Harestanes South Windfarm Extension

Environmental Impact Assessment Report Addendum

Appendix A1 – Consultation with SEPA

Electricity Works (Environmental Impact Assessment) (Scotland) Regulations 2017
Harestanes South Windfarm Extension, 13km north of Dumfries

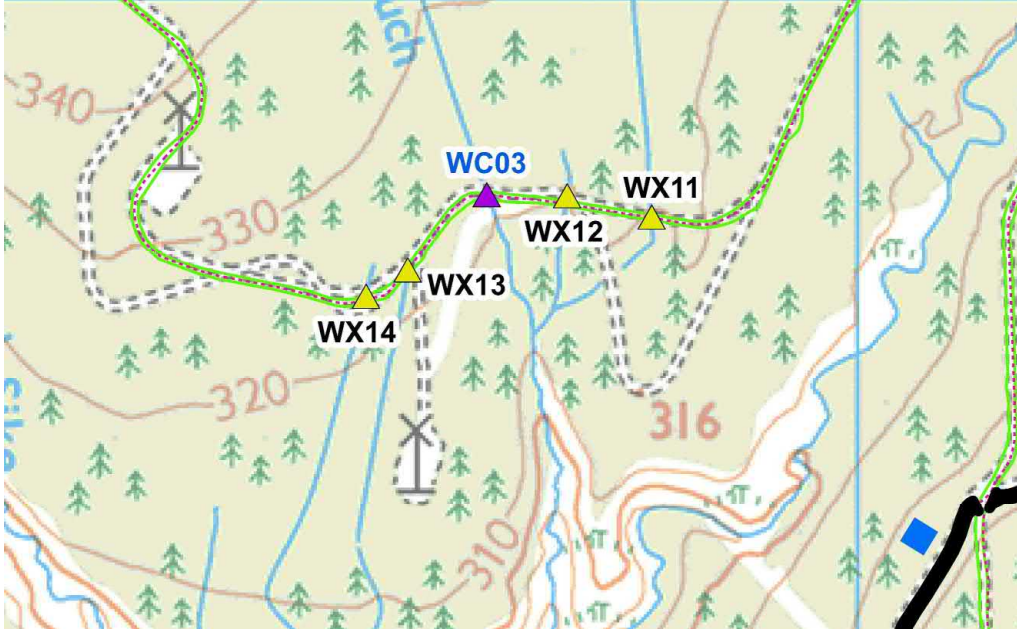
We discourage the realignment small headwater streams and the creation of ditches as a means of flow diversion. The drainage solutions provided in Diagram 10 (p16 of Appendix 6.4) are a more appropriate solution to prevent the ponding of water above the access track. Where realignment is considered the only viable option authorisation would be required.

We discourage the realignment small headwater streams and the creation of ditches as a means of flow diversion. The drainage solutions provided in Diagram 10 (p16 of Appendix 6.4) are a more appropriate solution to prevent the ponding of water above the access track. Where realignment is considered the only viable option authorisation would be required.

Text recommending this approach will be removed.

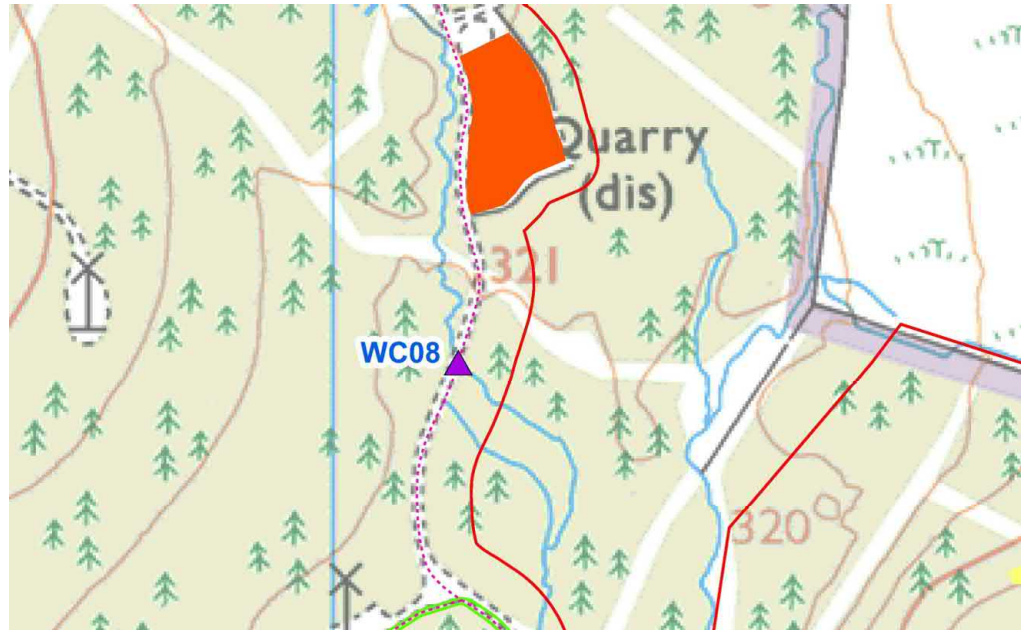
The pictures in Appendix B (of Appendix 6.4) do not appear to marry up with the description of the watercourses i.e. WC03 and WC04 the description says the channels are 4m and 6m wide respectively, but the photos don't seem to show a channel of that width, while WC09 says the channel is 1.8m wide but the pictures appear to show a wider channel. Clarification is required on whether the pictures match the descriptions.

The pictures in Appendix B (of Appendix 6.4) do not appear to marry up with the description of the watercourses i.e. WC03 and WC04 the description says the channels are 4m and 6m wide respectively, but the photos do not seem to show a channel of that width, while WC09 says the channel is 1.8m wide but the pictures appear to show a wider channel. Clarification is required on whether the pictures match the descriptions.

The watercourse descriptions do correspond with each of the photos; however, it seems that in some cases, such as the ones mentioned, the dimensions for the wider banks have been cited rather than for the actual watercourse channel. This is an error and will be rectified.
